**ADDENDUM NO. 3
NEW PORTABLE CLASSROOMS FOR SPRINGVILLE ELEMENTARY SCHOOL
AND MARGARET ELEMENTARY SCHOOL
Architect Job No. 22-68
March 3, 2023
DCM # 2023043**

SPRINGVILLE ELEMENTARY
SCHOOL - ELECTRICAL

MARGARET ELEMENTARY
SCHOOL - ELECTRICAL

E1.1

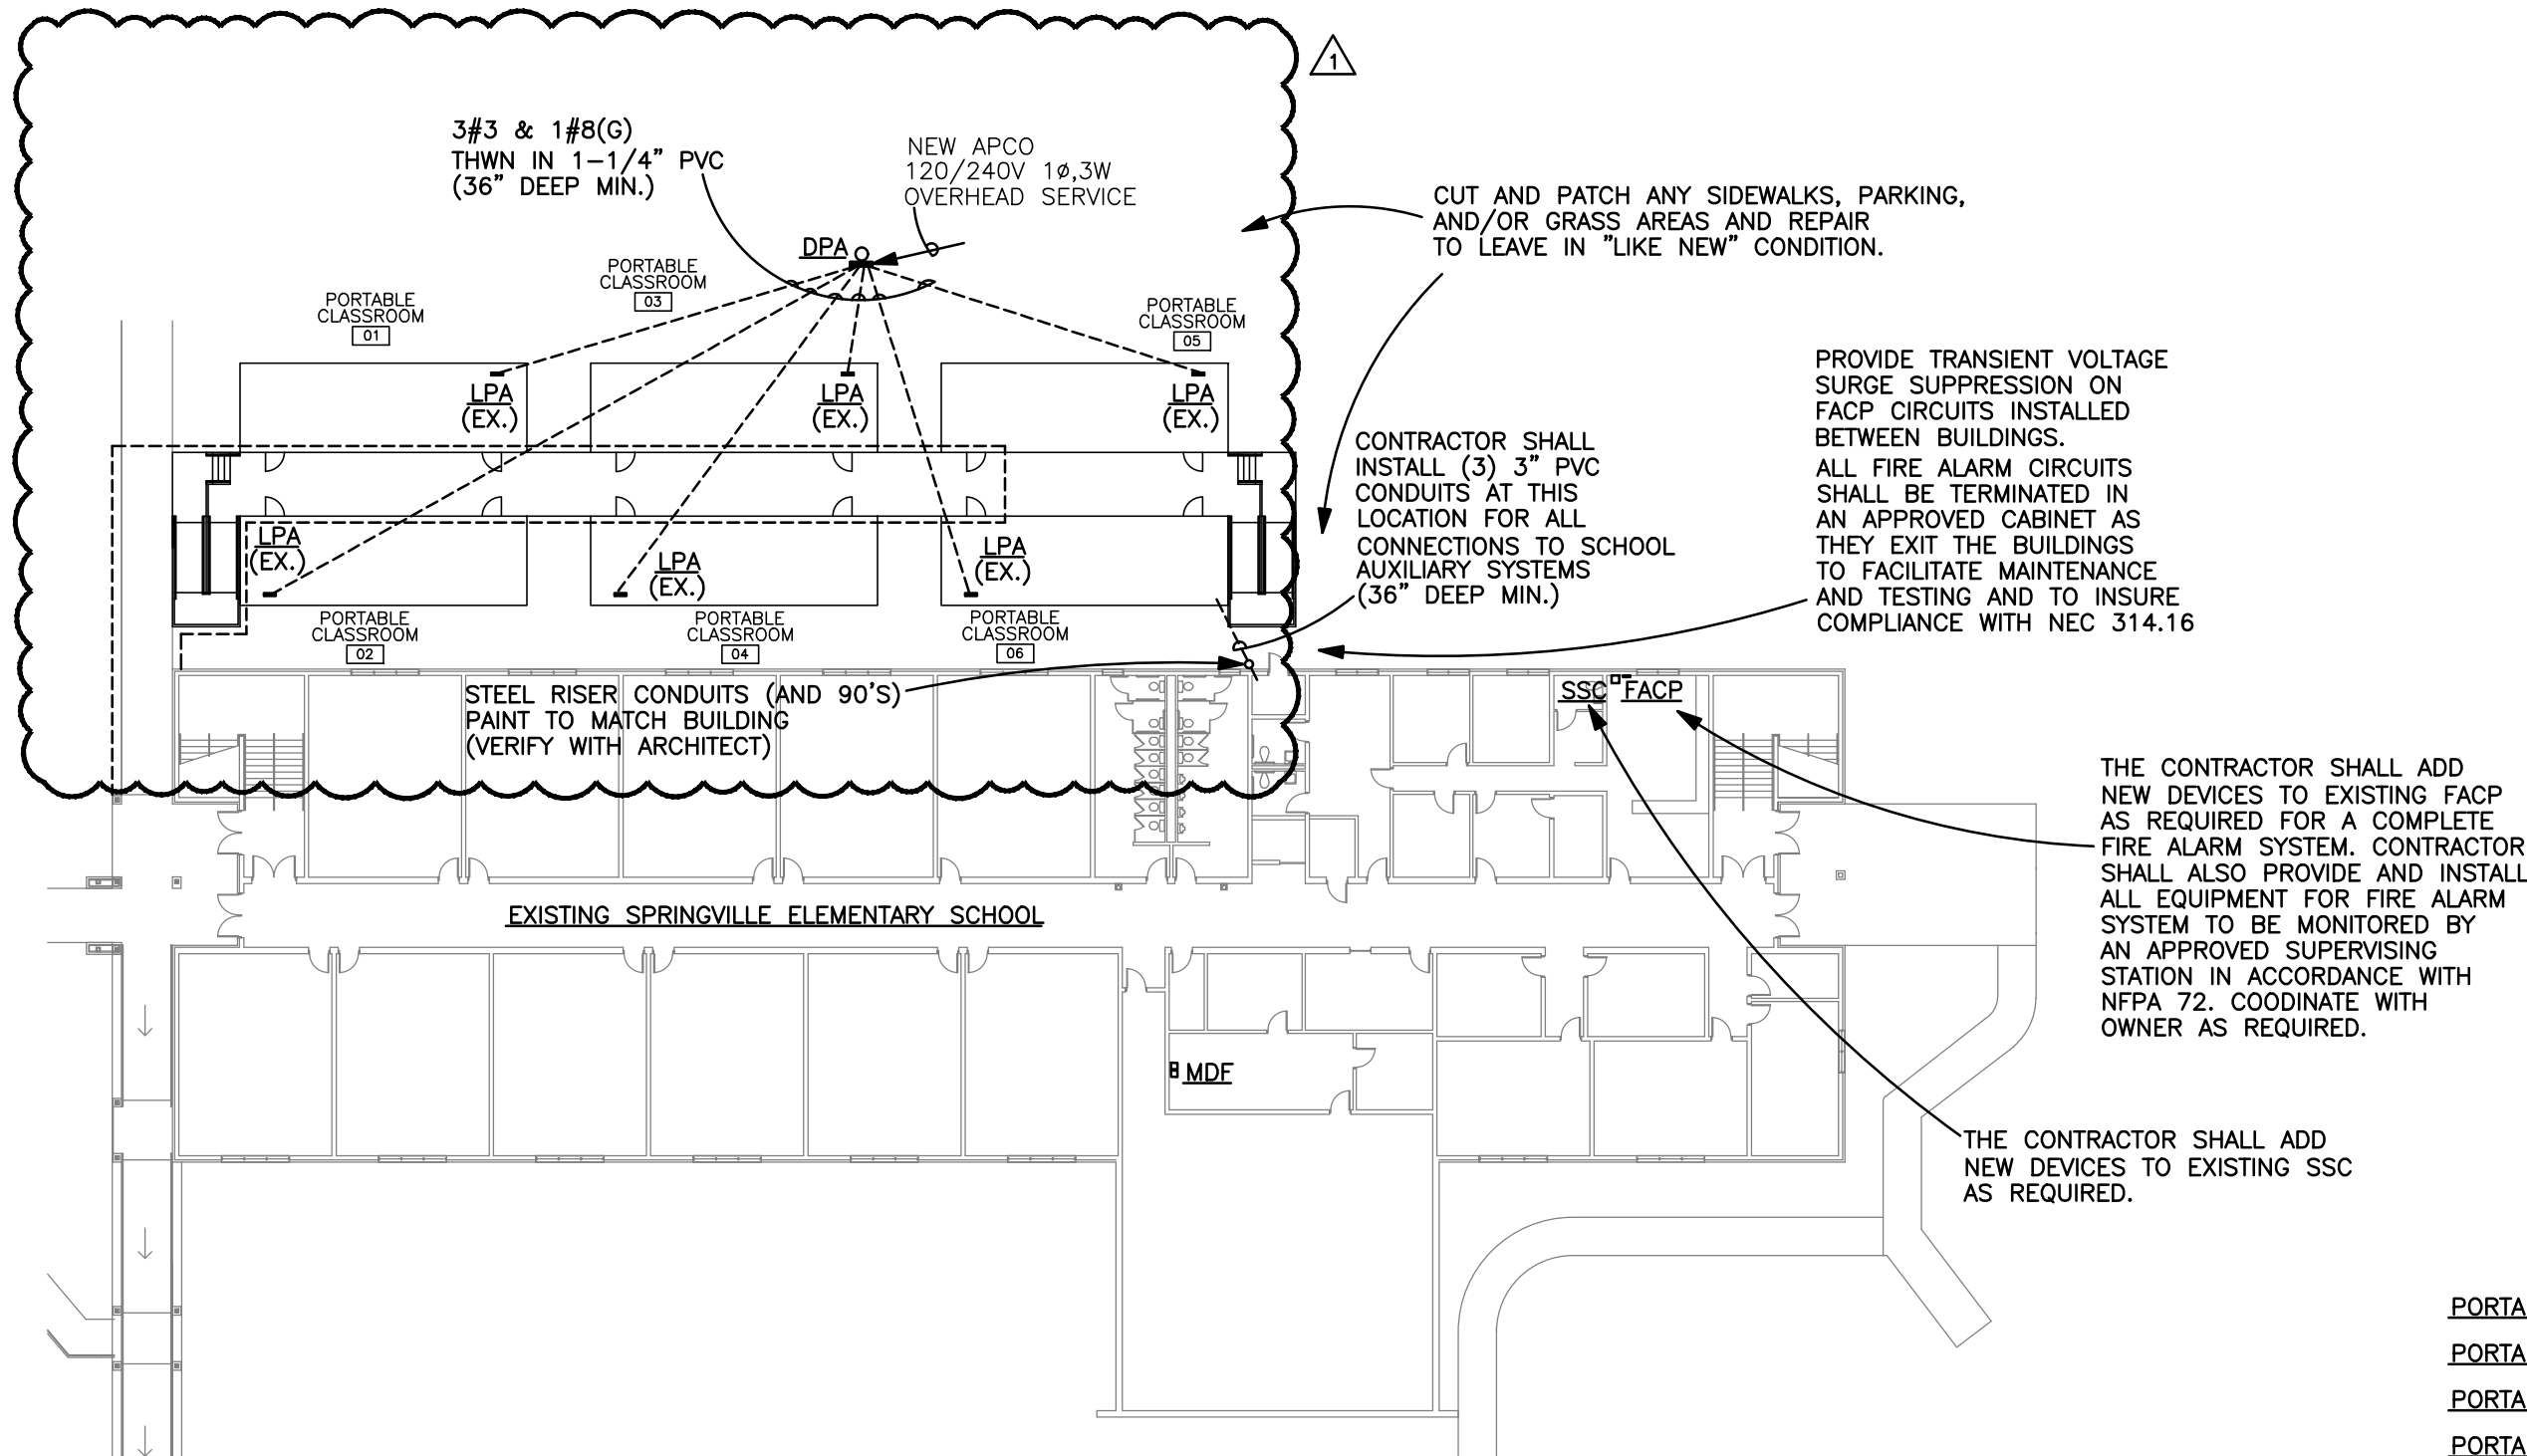
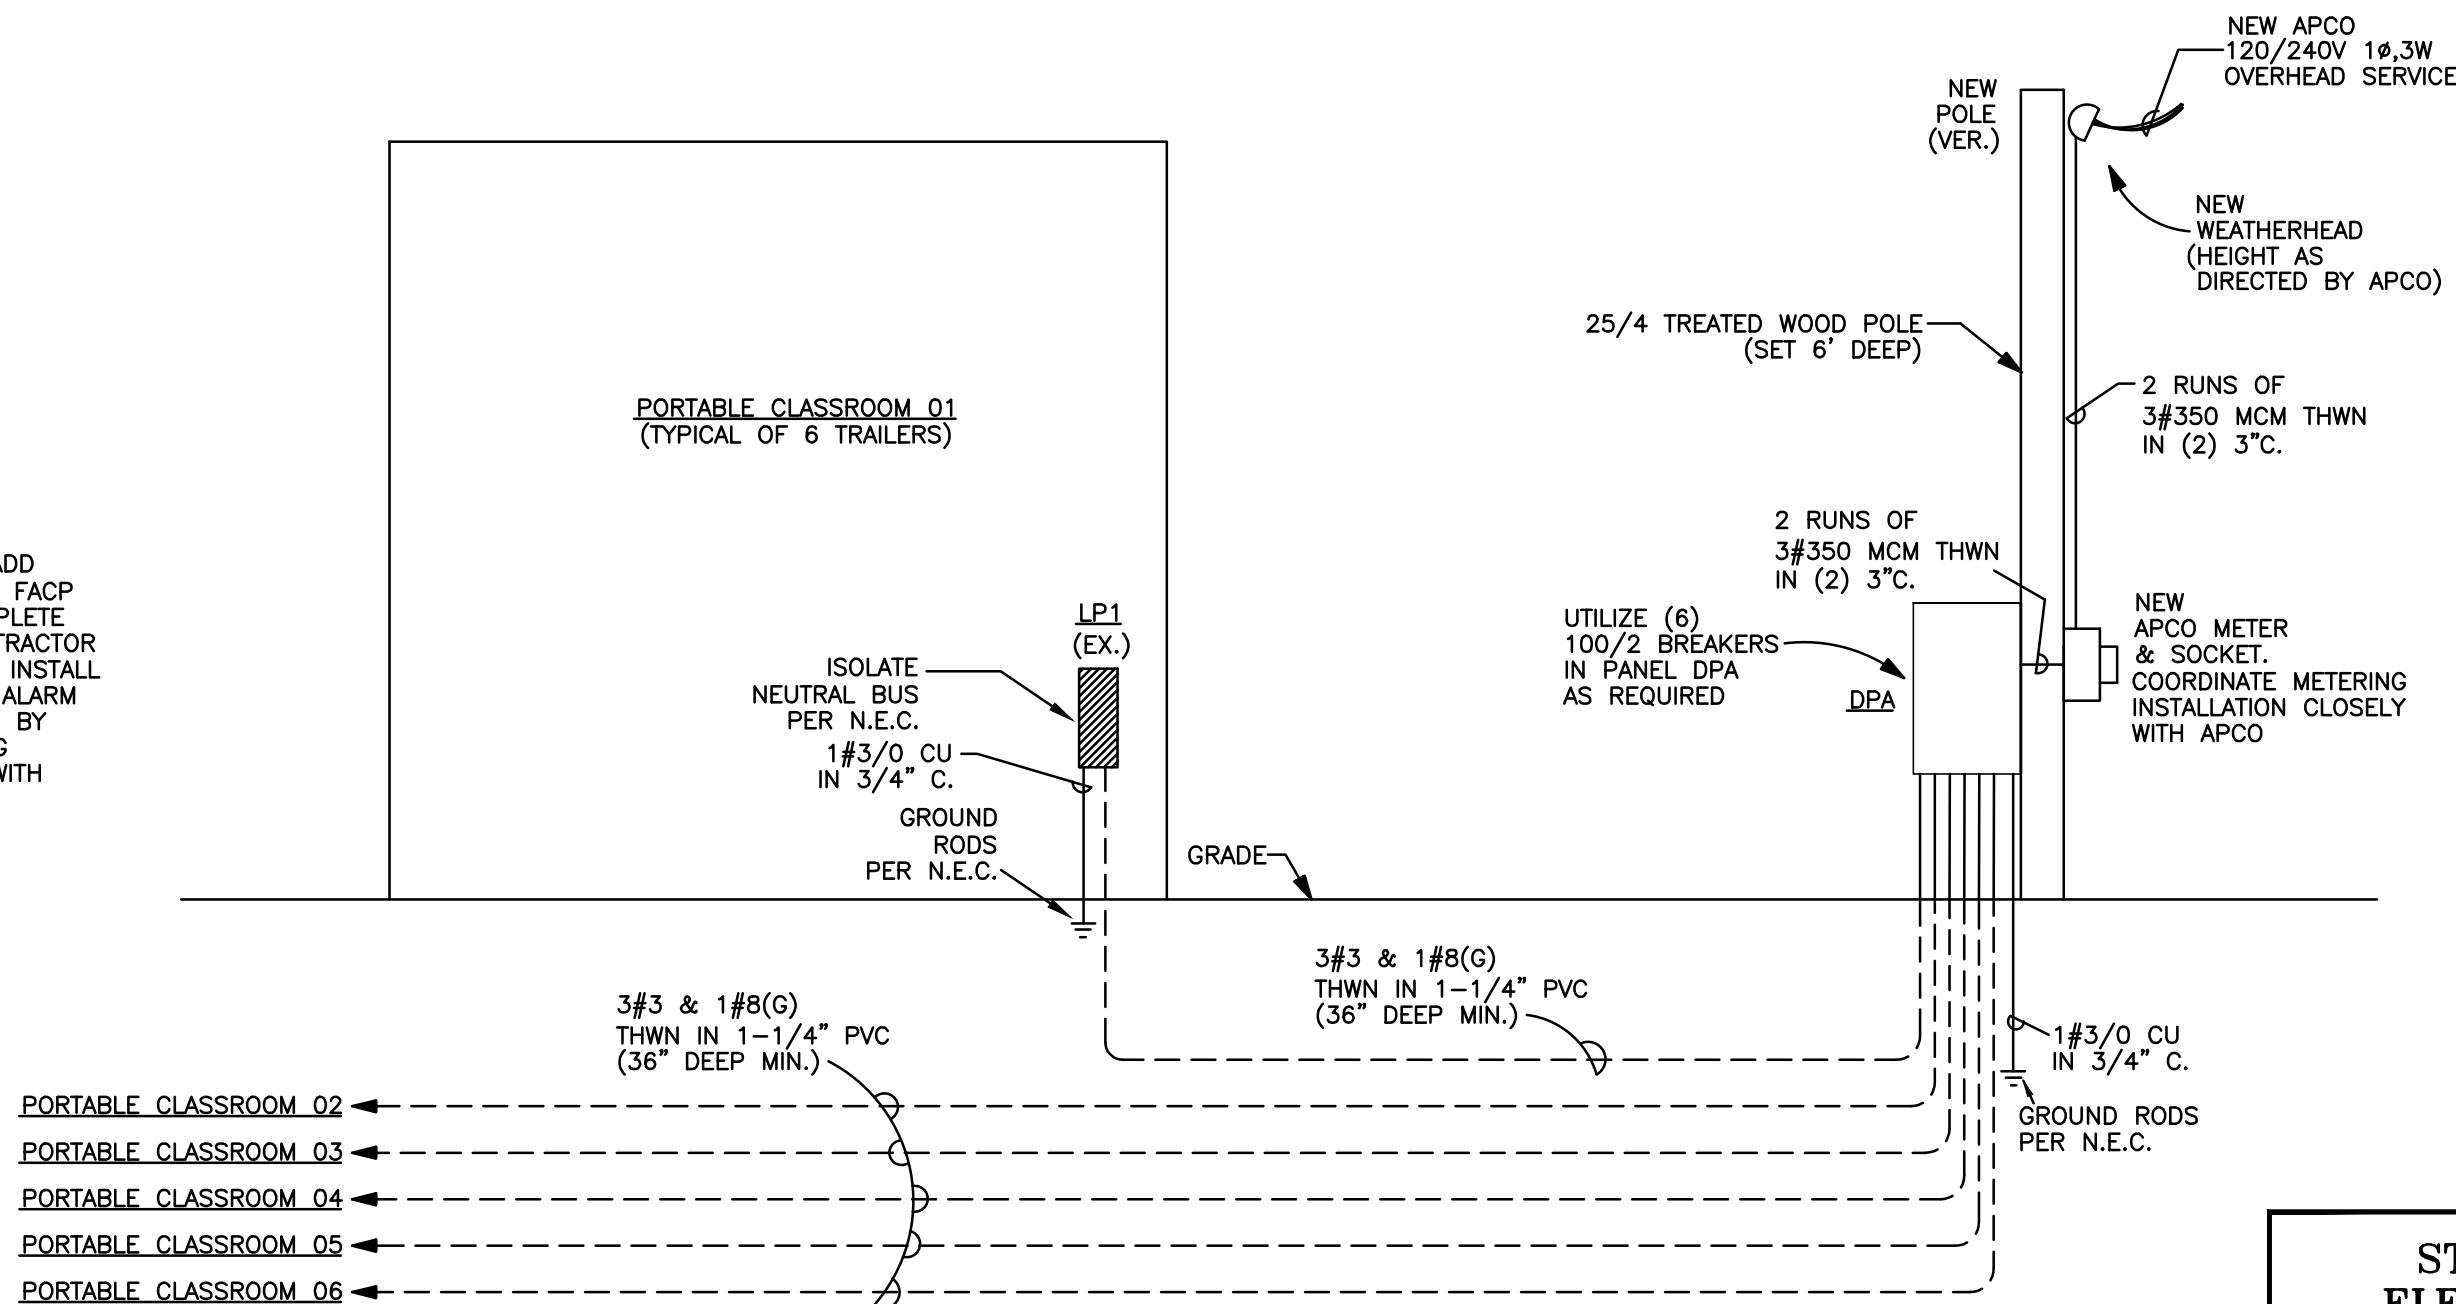
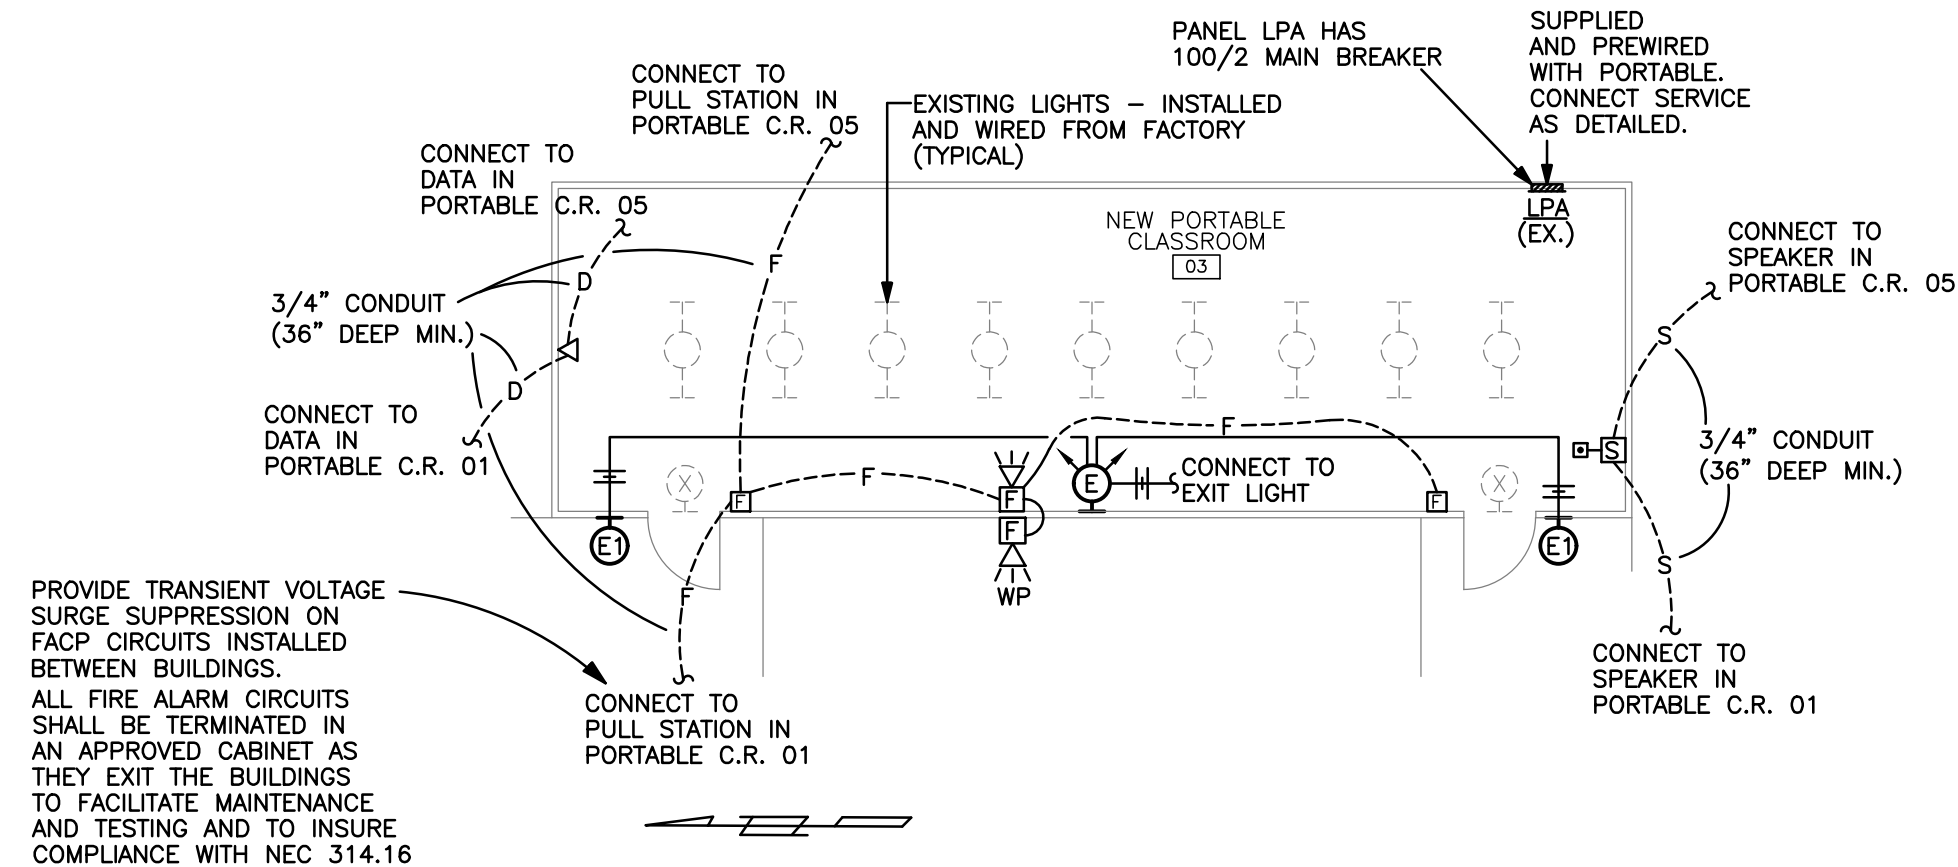
1. See attached **E1.1** for revisions.
2. See attached **E2.1** for revisions.
